Al Islam Textile Ltd.

9 Kornopara, Savar, Dhaka-1340
(23.824207N, 90.256342E)

27 APRIL 2014

Observations

Item 1 observation

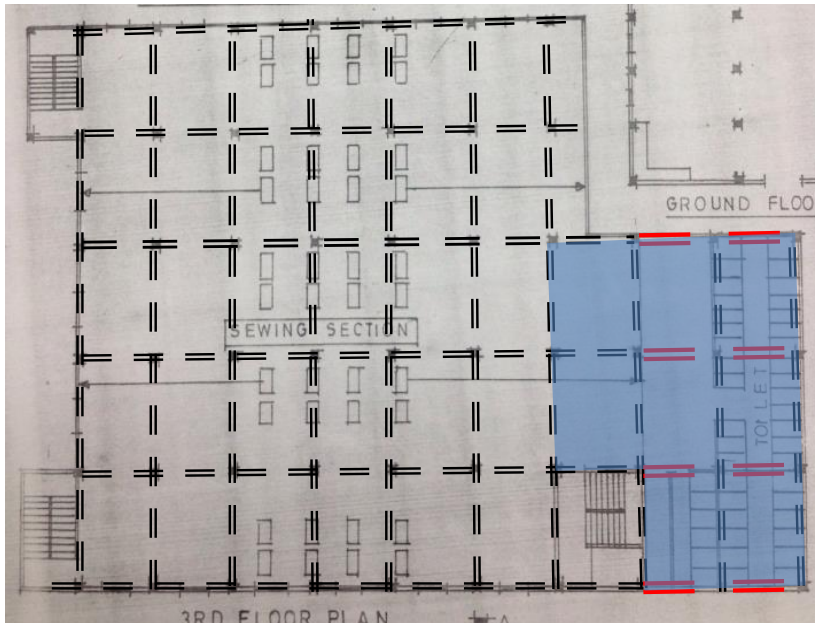
Column loads in excess of design loads

Verify concrete strengths in columns for all columns

Preliminary calculations suggest high stresses in columns.

Empty or relocate water tanks above area shaded in blue at roof level. Live load in area shaded in blue to maintained below 1kN/m^2 at all levels (ie toilet access only – no production or storage) until DEA proves adequacy of column design

Item No.	Observation	Recommended Action Plan	Recommended Timeline
1	Column loads in excess of design loads Verify concrete strengths in columns for all columns	NO further levels to be built. Water tanks at roof level in blue area should be removed or relocated	Immediate - Now
2	Column loads in excess of design loads Verify concrete strengths in columns for all columns	Live load in area shaded blue to be maintained below 1kN/m2 at all floor levels (ie toilet access only – no production or storage)	Immediate - Now
3	Column loads in excess of design loads Verify concrete strengths in columns for all columns	Factory Engineer to review design, loads and columns stresses of all columns.	Immediate - Now
4	Column loads in excess of design loads Verify concrete strengths in columns for all columns	Verify insitu concrete stresses by 100mm diameter cores from minimum 4 columns in the building part from 1996 and 2 columns in the building part from 2011 (recent extension). All cores to be taken at Ground Floor.	Immediate - Now

Item 2 observation

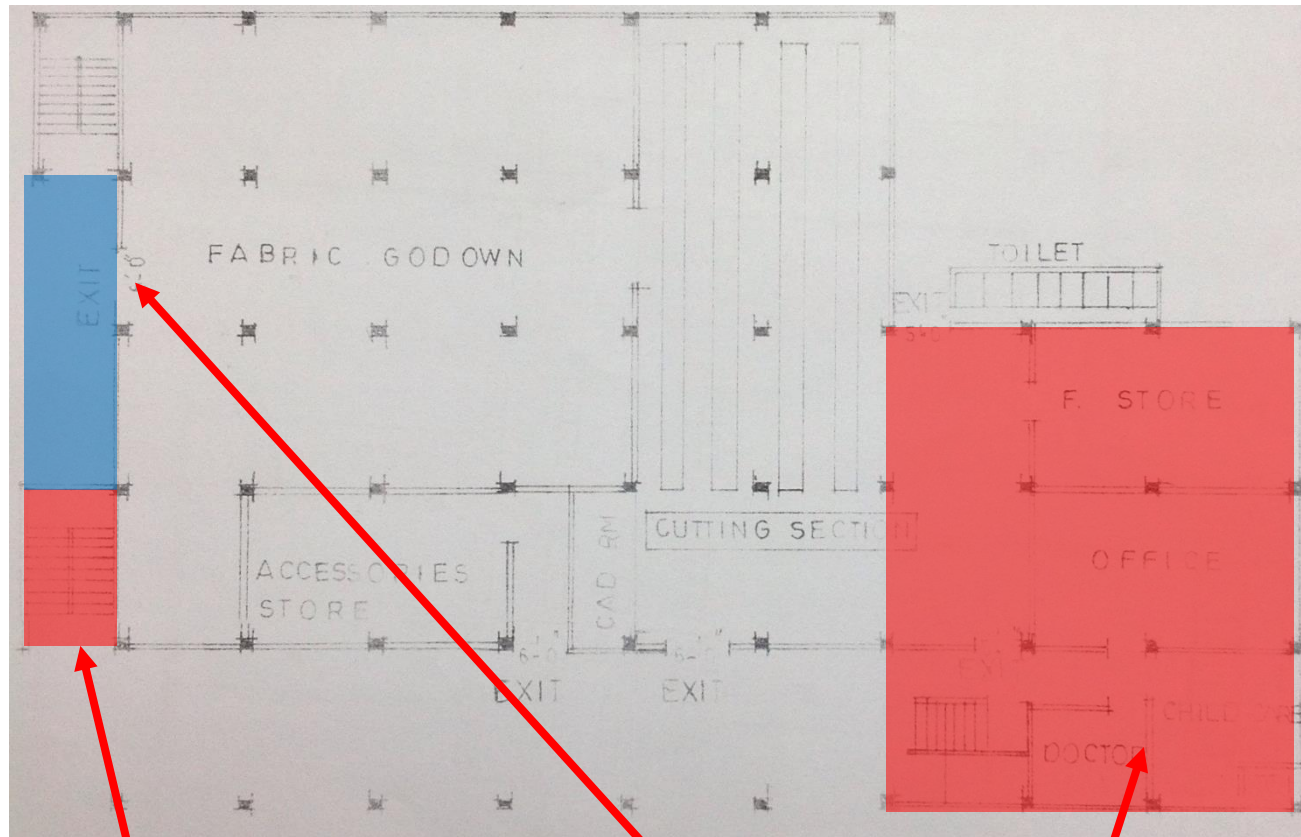
Documentation issues, Steel stair design and additional building was not shown.

No structural information was provided for the areas shown.

The owner informed us that the second and third floors were constructed using the original designs.

The steel shed recently built for storage (not shown in this sketch) is also not documented

No structural documentation of steel stair

No structural documentation of Generator room

No structural documentation of the 4 storey Building extension

Item No.	Observation	Recommended Action Plan	Recommended Timeline
6	Column loads in excess of design loads Verify concrete strengths in columns for all columns	Produce and actively manage a loading plan for all floor plates within the factory giving consideration to floor capacity and column capacity.	6-weeks
7	Column loads in excess of design loads Verify concrete strengths in columns for all columns	Detail Engineering Assessment to be completed	6-weeks
8	Column loads in excess of design loads Verify concrete strengths in columns for all columns	Continue to implement load plan	6-months
9	Documentation issues Steel stair design and additional building was not shown	Building engineer to check, collect information and produce accurate and complete as-built documentation as part of DEA	6-weeks
10	Documentation issues Steel stair design and additional building was not shown	As-built documentation to be complete.	6-months

Item 3 observation

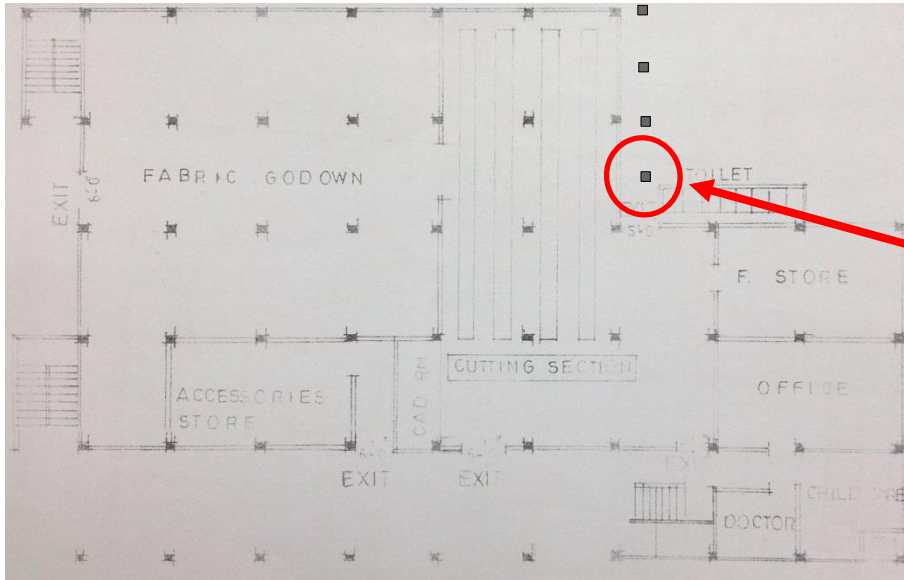
localized high loading from water tanks

Water tanks observed on roof.

- 3no. 2000 lt. tanks by parapet
- 7no. 3000 lt. tanks by stairwell

Hairline cracking observed on underside of supporting beam.

Item No.	Observation	Recommended Action Plan	Recommended Timeline
11	localized high loading from water tanks	Reduce water storage on the roof as much as possible – see Item 1	Immediate - Now
12	localized high loading from water tanks	Disperse cluster of water tanks and place one tank per supporting column.	Immediate - Now
13	localized high loading from water tanks	As a result of the DEA the building engineer may advise where the water storage can be placed safely without distressing any structural elements (slabs / beams and columns).	6-weeks
14	Offset column/beam connection detail is a concern	Carry out detail calculation for offset beam/column connection and provide additional column to foundation level if necessary	6-weeks
15	Cantilever landing between ground and first floor stairwell	Building engineer to check the capacity of the supporting column and propose additional reinforcements and stability system, if required.	6-weeks

Item 4 observation

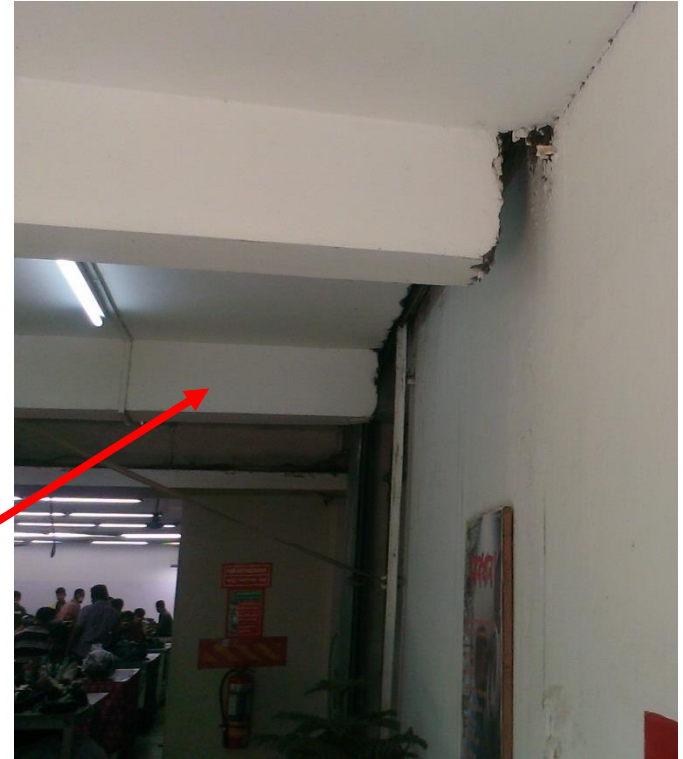
Offset column/beam connection detail is a concern.

Concern with connection detail between primary and secondary beams with columns – limited bearing

Columns offset from beam centerline

Item 9 observation

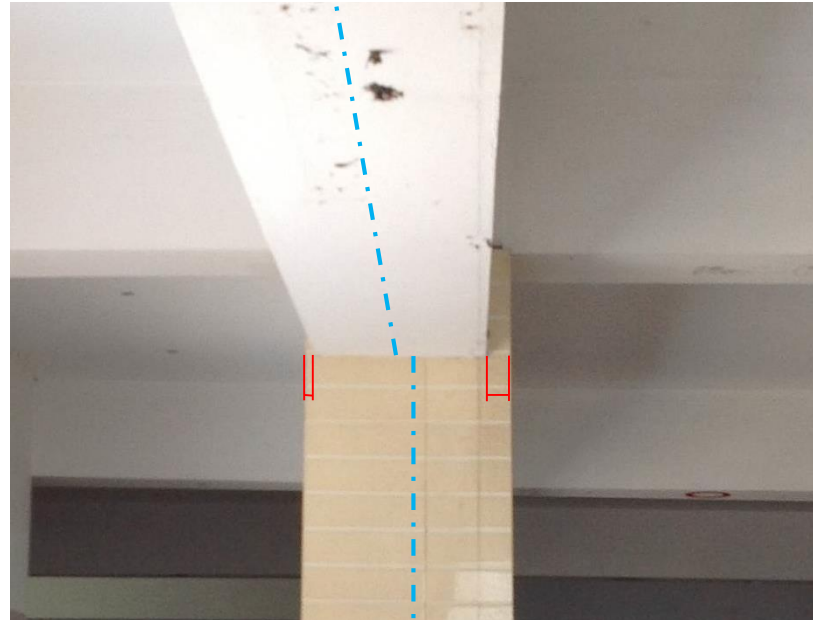
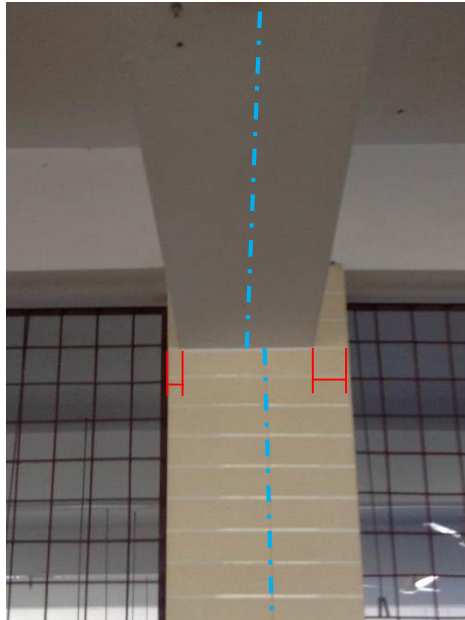
Some piers of internal / external brick wall partitions / façade not extending to soffit of beam and by that not horizontally restrained at their top. Reduced resistance to horizontal loads (e.g. wind loads)

Ground floor between
childcare and medical room
(Internal wall)

1st floor by stairwell (Internal
wall)

1st floor office (External wall)

Item No.	Observation	Recommended Action Plan	Recommended Timeline
24	Non engineered structure shed	Building engineer to check the structures and propose additional reinforcements of stability system.	6-weeks
25	Non engineered structure shed	Strengthening as instructed by building engineer or removal of shed.	6-months
26	Brick columns/Piers not extending to soffit of beam at ground level between medical room and childcare, at first floor level between work area and stairwell and external façade on first floor level in office area	Building Engineer to review piers	6-weeks
27	Brick columns/Piers not extending to soffit of beam at ground level between medical room and childcare, at first floor level between work area and stairwell and external façade on first floor level in office area	If required, extend piers to soffit of second floor beam or provide other adequate means for making the walls resistant to wind loads.	6-months

Item 11 observation

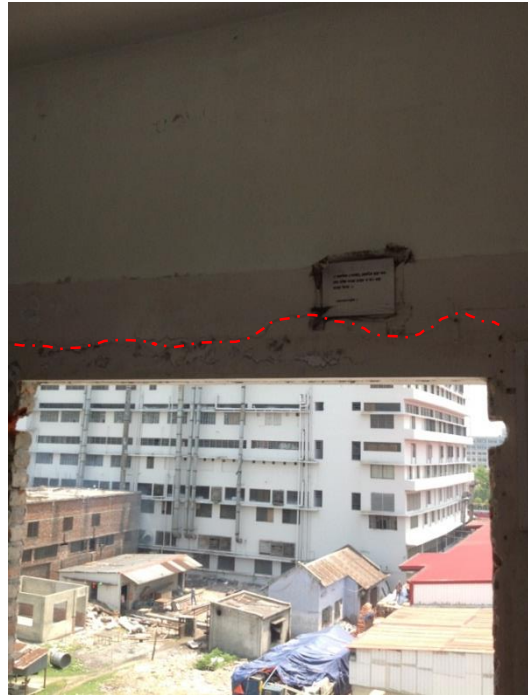
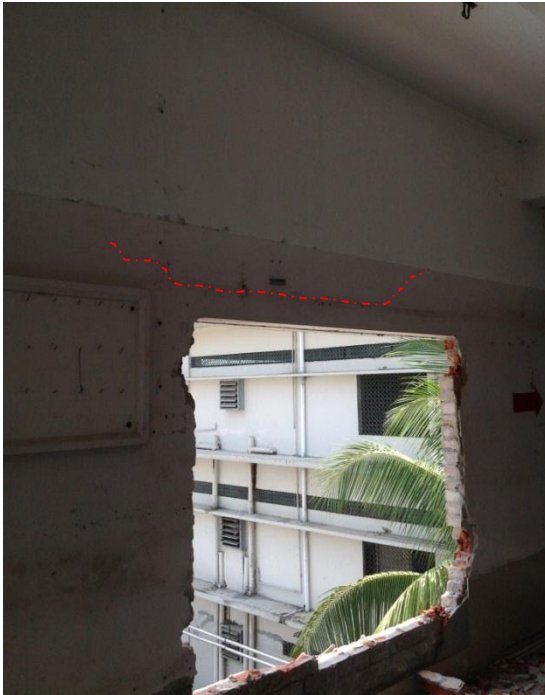
Columns exposed to impact

Impact protection not provided to columns on south elevation. Columns are susceptible to impact loading from vehicles.

Item No.	Observation	Recommended Action Plan	Recommended Timeline
28	Eccentric connections between beams and columns observed at third floor level	Address as part of the general DEA and take eccentricity into account when doing the column checks.	6-weeks
29	Impact protection to columns	Building Engineer to review column design and potential for vehicle impact to columns on south elevation. If appropriate impact protection to be provided.	6-weeks
